Access Compliance Report Public Rights-of-Way (Curb Ramps)

Intersection ID: 48421	Main Street: EVANTON_LOCH_RD	Cross Street: CULLEN_CT	Location:	N
ADA ID: EF820AB0B28D	Ramp Type: Perp	Initial Pass/Fail: Fail	Overall Compliance: No	Severity Score: 21.25

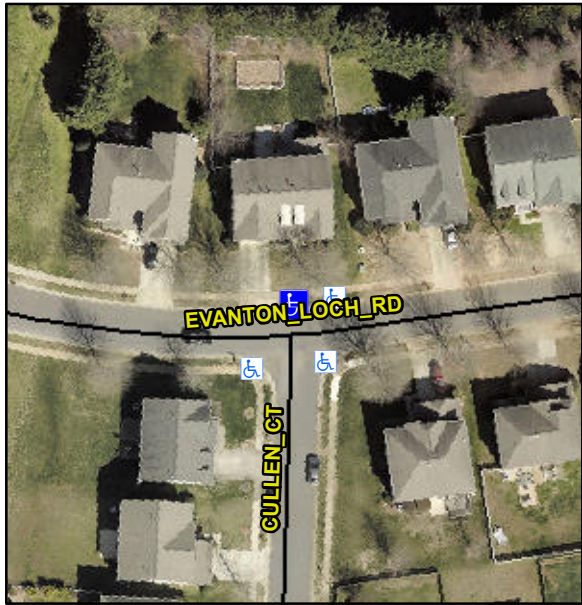
Codes/Mitigation Info/Possible Solution			Field Measurements/Component Compliance							
	Possible Solutions:		Compliance			Description			Data	
	Remove & Replace Entire Ramp.		N/A		Ramp Length (in)	46.0	No	Ramp Slope (%)	9.5	
			No		Ramp Width (in)	46.0	Yes	Ramp XSlope (%)	1.0	
			N/A		Flare Type LT	N/A	N/A	Flare Type RT	N/A	
			N/A		Flare Slope LT (%)	N/A	N/A	Flare Slope RT (%)	N/A	
			N/A		Flare Traversable LT?	N/A	N/A	Flare Traversable RT?	N/A	
			N/A		Landing Length (in)	N/A	N/A	DWS Provided?	N/A	
			N/A		Landing Width (in)	N/A	N/A	DWS Contrast?	N/A	
			N/A		Landing Slope (%)	N/A	N/A	DWS Length (in)	N/A	
			N/A		Landing X Slope (%)	N/A	N/A	DWS Full Width?	N/A	
Surveyor Notes:	N/A		N/A		Landing Curb? (Y/N)	N/A	N/A	DWS Offset (in)	N/A	
			N/A		Shared Landing?	N/A				
			N/A		Gutter Ponding?	N/A	N/A	Gutter Slope (%)	N/A	
			N/A		Gutter Lip Ht (in)	N/A	N/A	Gutter X Slope (%)	N/A	
			N/A		Painted X Walk1?	No	N/A	Painted X Walk2?	N/A

X Walk 1 Direction	To SW		X Walk 2 Direction	N/A	
			N/A		X Walk 1 Width (in)	N/A	N/A	X Walk 2 Width (in)	N/A	
					X Walk 1 Slope (%)	2.9		X Walk 2 Slope (%)	N/A	
					X Walk 1 X Slope (%)	5.1		X Walk 2 X Slope (%)	N/A	
			N/A		Ramp inside XWalk1?	N/A	N/A	Ramp inside XWalk2?	N/A	
PROW/ADA:	R304.5.1, R304.2.2				Road Slope (%)	N/A	N/A	Clear Space?	N/A	
					Road X Slope (%)	N/A	N/A	Clear Space to XWalk (in)	N/A	
			N/A		Any Obstructions?	N/A	N/A	Storm Grate/Utility Hazard?	N/A	
					Obstruction Type			Storm Grate/Utility Type		
						N/A			N/A	
							Yes	Surface Condition? (G/P)	Good	
Street 1 Name		EVANTON LOCH RD								
Stop Condition-Street 2		None								
Street 2 Name		N/A								
Stop Condition-Street 1		N/A								
Total Cost:			\$	1850.00
